Title RH-AMP INPUT MOD.			
Size	Number	Rev	
D	700-PCA082	F	
Date	12/28/94	Drawn by	F.O.
Filename	DOO057-F.S02	Sheet	2 of 2

Title: OUTPUT STAGE, CHANNEL PCB, AMPLIFIER, 1500W

RENKUS-HEINZ, Inc.	
Title: AC INPUT MODULE	
Size: D	Number: 700-PCA103
Date: 12/06/94	Drawn by: R.N.S.
Filename: D00653-H-501	Sheet: 1 of 1

RENKUS-HEINZ, Inc.		Title		POWER SUPPLY
		Size		Number
Date		12/06/94		Rev
Filename		D00053-K.S01		K
Sheet		1 of 1

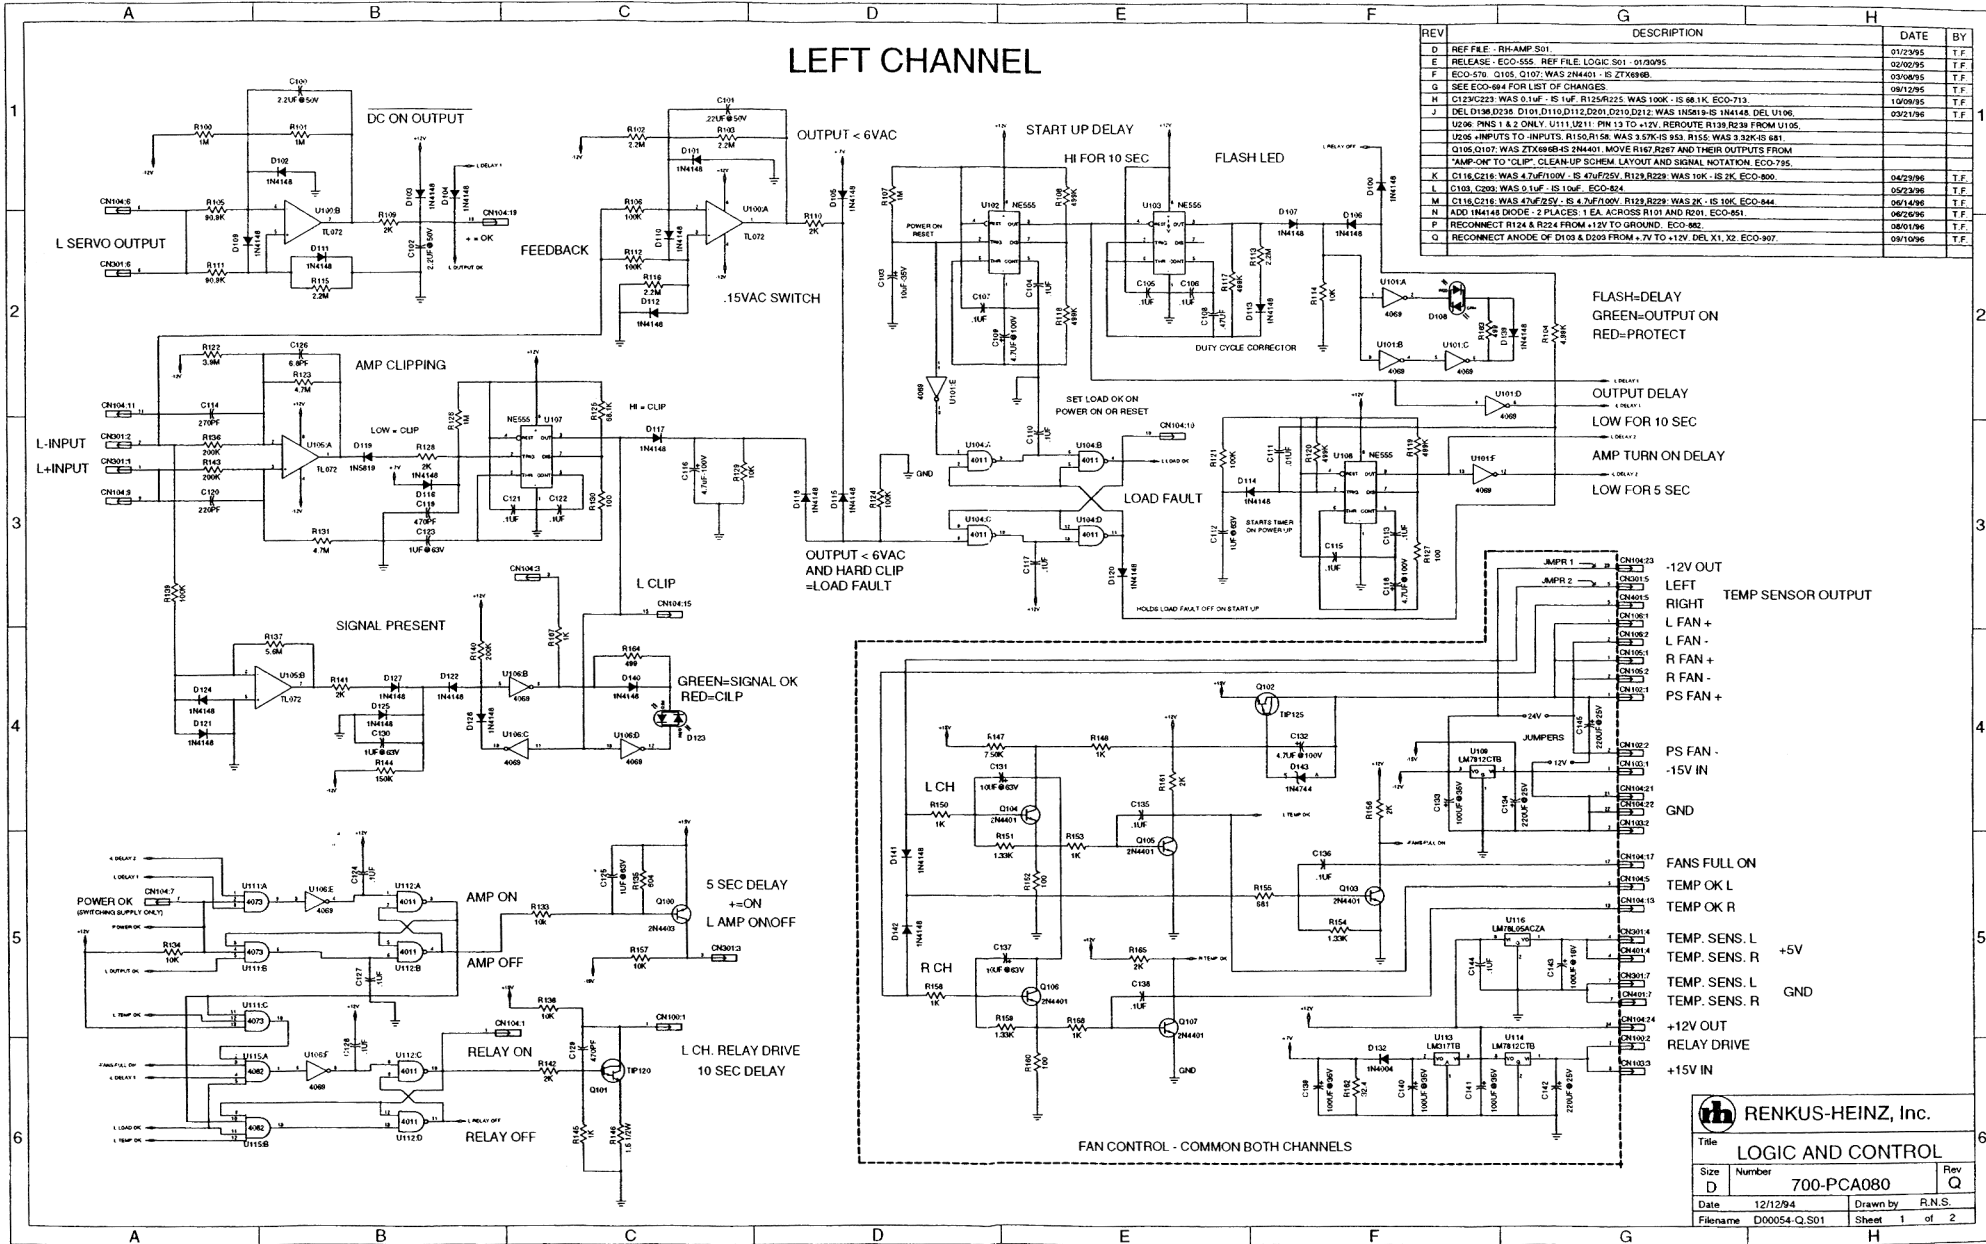
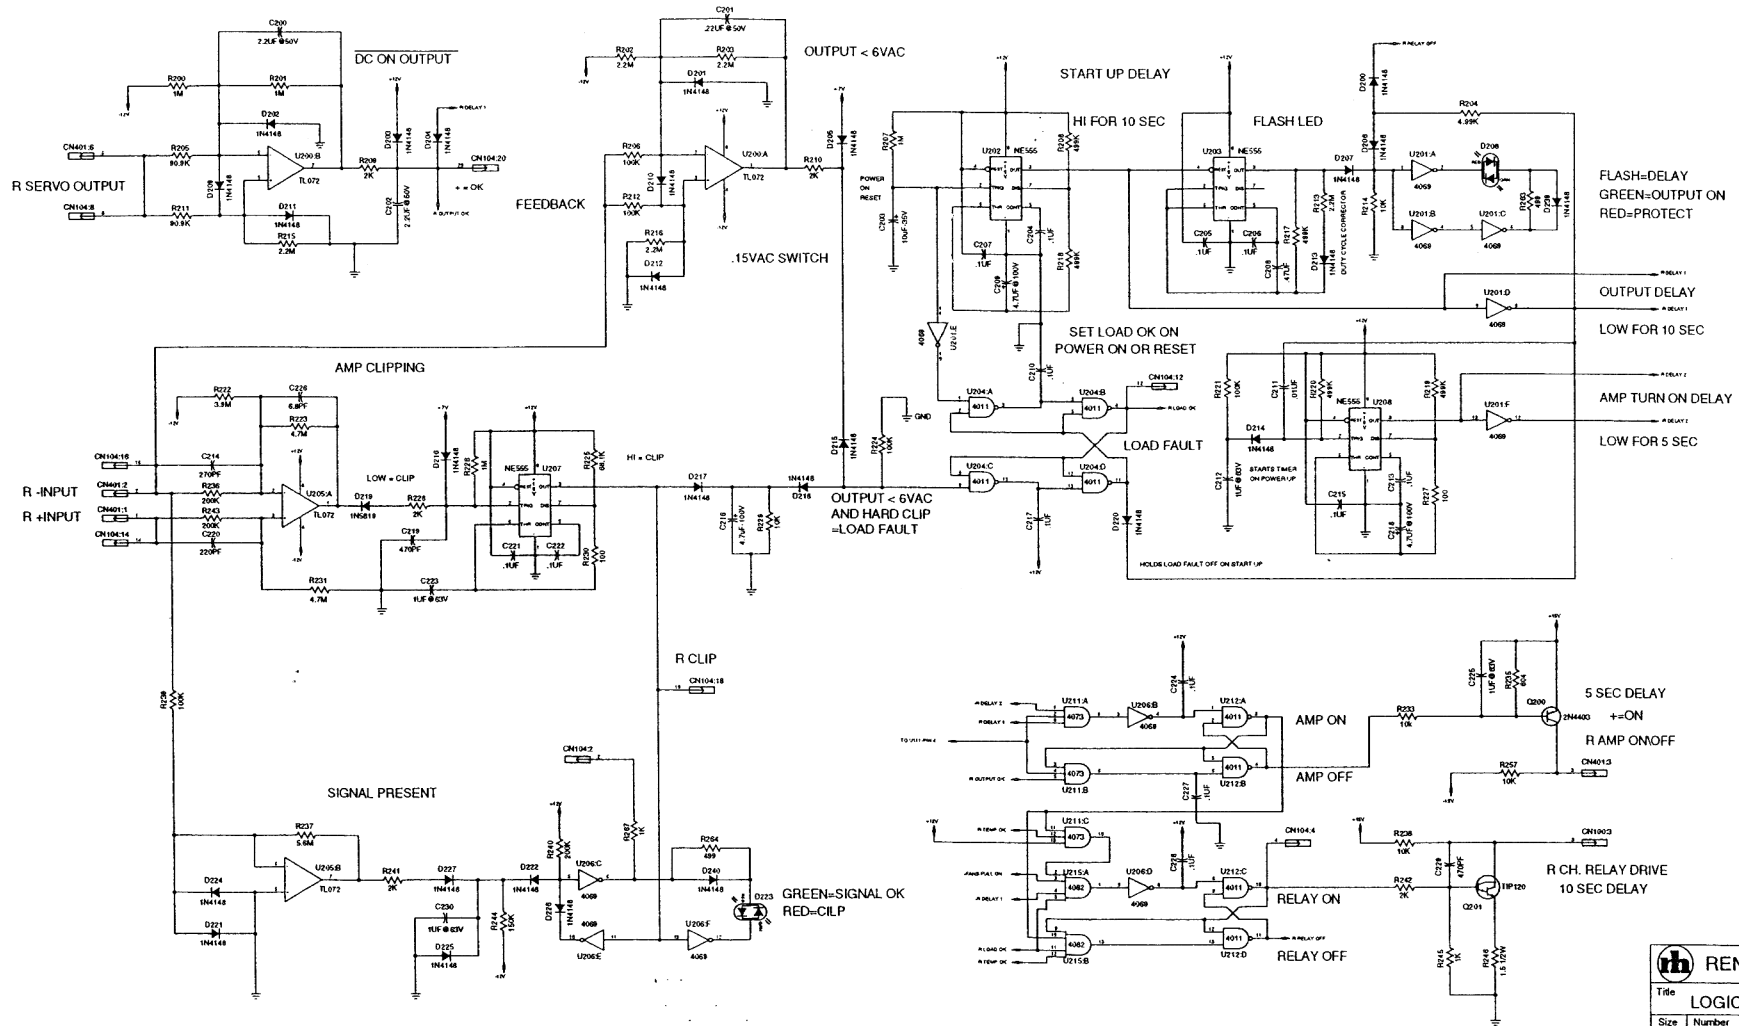
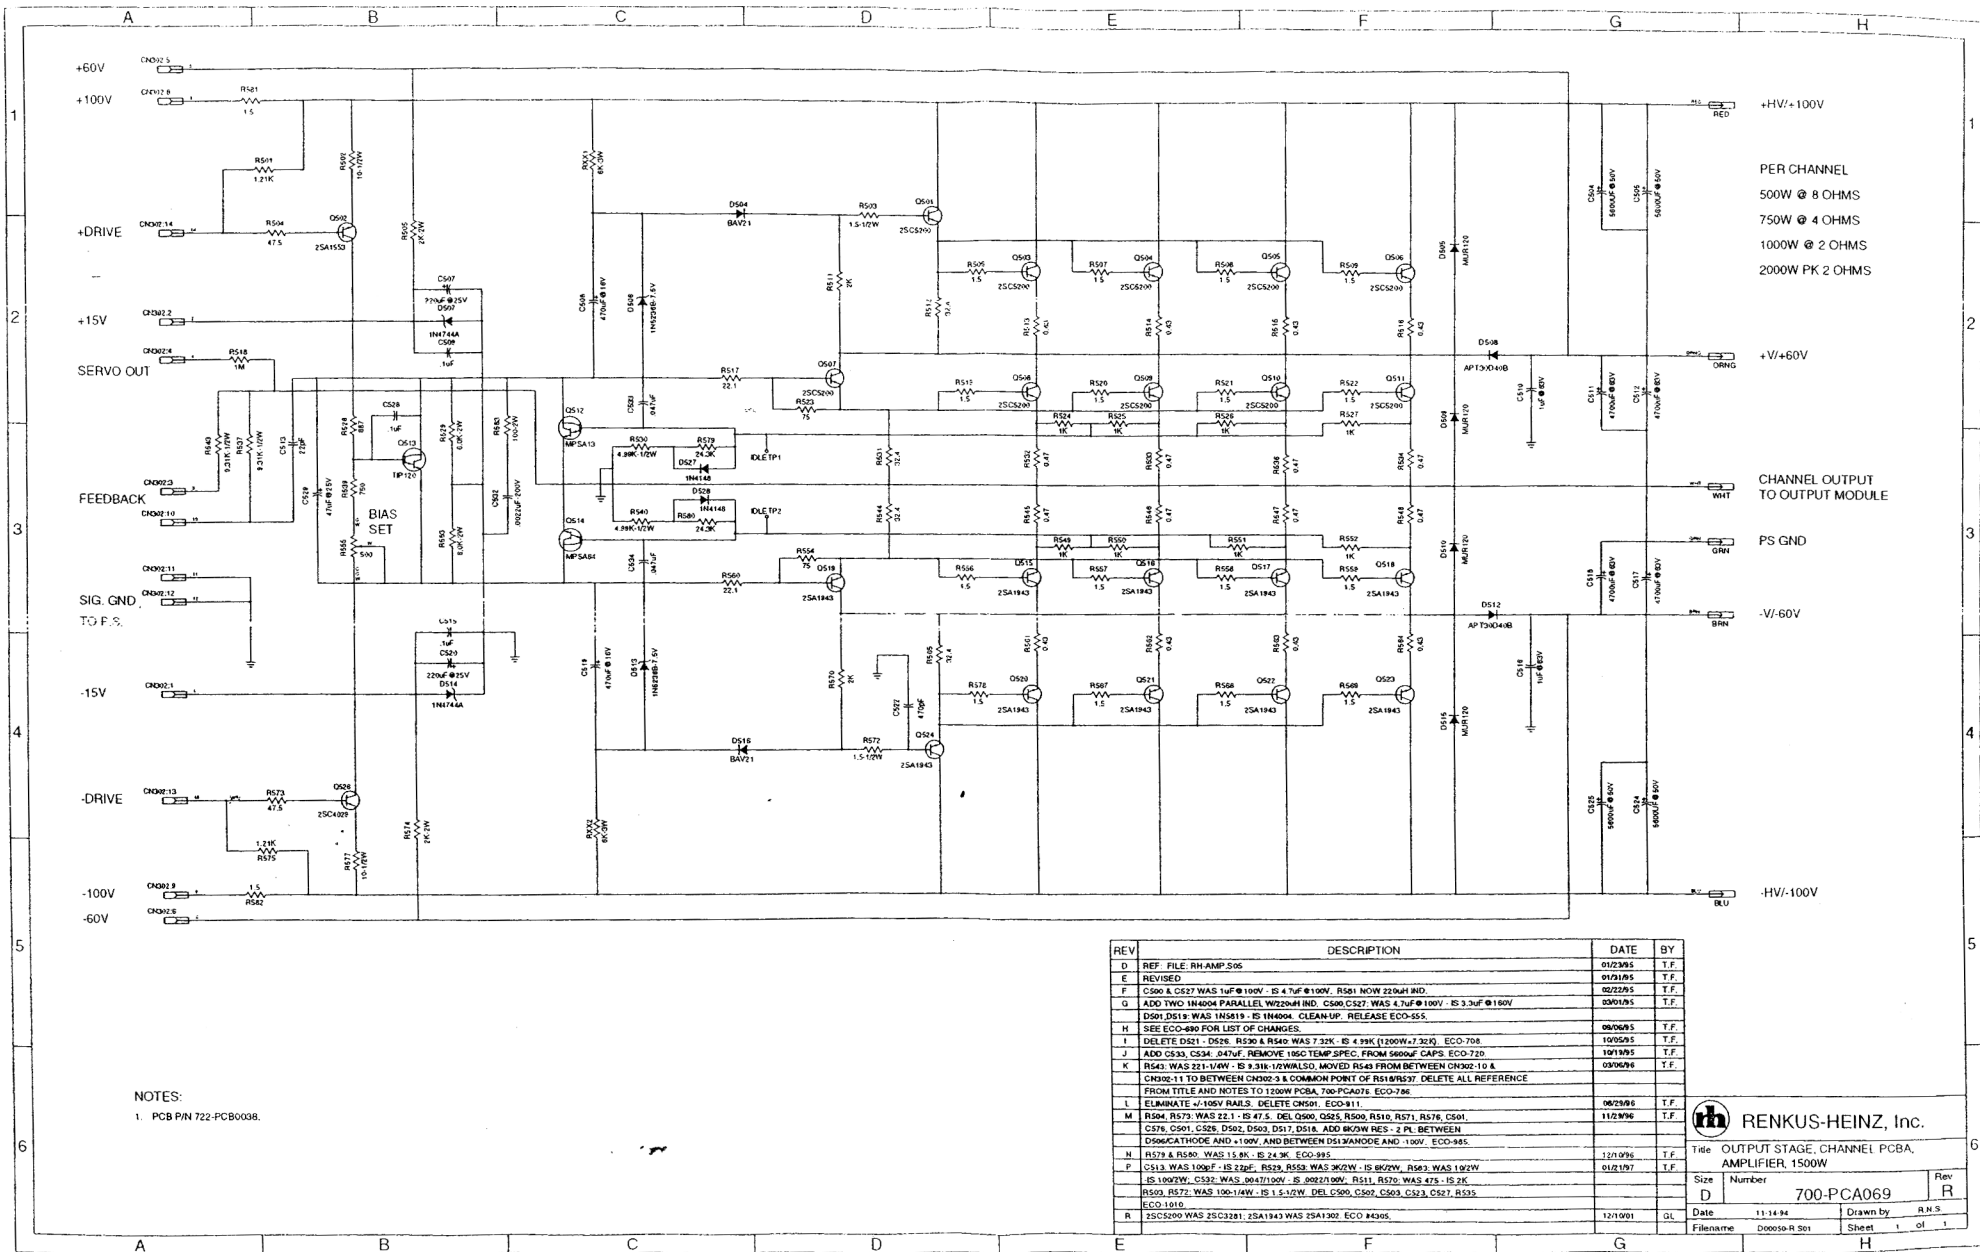
REV	DESCRIPTION	DATE	BY
D	REF. FILE: RH.AMP.506	01/23/95	T.F.
E	REVISED	01/21/95	T.F.
F	C500 & C527 WAS 1uF @ 100V - IS 4.7uF @ 100V. R501 NOW 220uH IND.	02/22/95	T.F.
G	ADD TWO 1N4004 PARALLEL 1W/200V IND. C500 C527 WAS 4.7uF @ 100V - IS 3.3uF @ 160V	03/01/95	T.F.
H	D501, D516 WAS 1N5819 - IS 1N4004. CLEANUP. RELEASE ECO-555.	08/06/95	T.F.
I	SEE ECO-480 FOR LIST OF CHANGES.	08/06/95	T.F.
J	DELETE D521 - D526. R530 & R540 WAS 7.32K - IS 4.99K (1200W-1.32K). ECO-708	10/05/95	T.F.
K	ADD C533, C534. 0.47uF. REMOVE 195C TEMP SPEC. FROM 5600uF CAPS. ECO-720	10/19/95	T.F.
L	R543 WAS 221-1uH - IS 9.31K-1/2W/LSO. MOVED R543 FROM BETWEEN C502-10 & C502-11 TO BETWEEN C502-3 & COMMON POINT OF R518/R520. DELETE ALL REFERENCE FROM TITLE AND NOTES TO 1200W PCB, 700-PCA076. ECO-746	03/06/96	T.F.
M	ELIMINATE +/-105V RAILS. DELETE C501. ECO-911	06/25/96	T.F.
N	R504, R573 WAS 22.1 - IS 47.5. DEL C500, C525, R500, R510, R571, R576, C501, C576, C501, C526, D502, D503, D517, D518. ADD 800W RES - 2 PL. BETWEEN DIODE CATHODE AND +100V. AND BETWEEN DIODE ANODE AND -100V. ECO-985	11/2/96	T.F.

O	R579 & R580 WAS 15.8K - IS 24.3K. ECO-995	1/27/98	T.F.
P	C513 WAS 100uF - IS 22uF. R529, R559 WAS 3K/2W - IS 8K/2W. R563 WAS 100W - IS 100W/2W. C532 WAS 0.047/100V - IS 0.022/100V. R511, R570 WAS 475 - IS 2K. R509, R572 WAS 100-1/4W - IS 1.5-1/2W. DEL C500, C507, C503, C523, C527, R539. ECO-1016	01/21/97	T.F.
R	25C5200 WAS 25C3281. 25A1943 WAS 25A1307. ECO #4305.	12/10/01	GL
